Sent: 27 May 2026 17:31
To: Planning
Subject: Objection to DC/26/0585

I would like to object to planning application DC/26/0585 on the basis of pedestrian and vulnerable road user safety

iMap

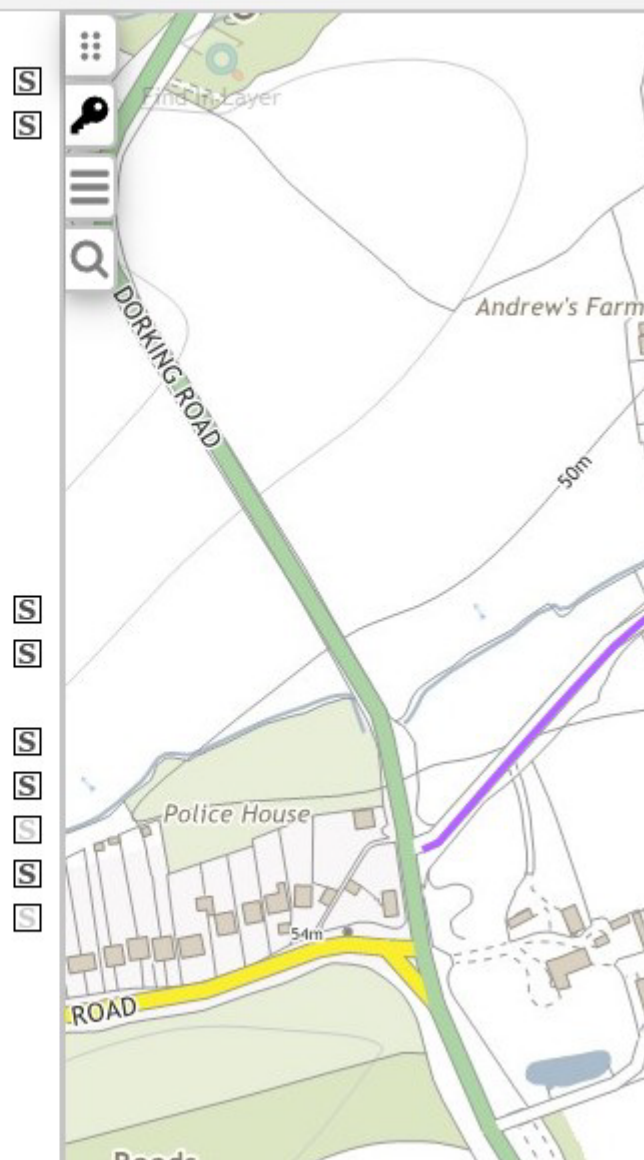
The public right of way for these uses is formally noted, as per the snip below, as WAR1574. This signposted footpath is in the road, it is not a separate footpath alongside the road and separated by a kerb

Neither the Transport Statement, the Travel Plan Statement or the Transport Statement (Sensitive) highlight that Station Road is a public right of way footpath. This is a gross omission by the Applicant
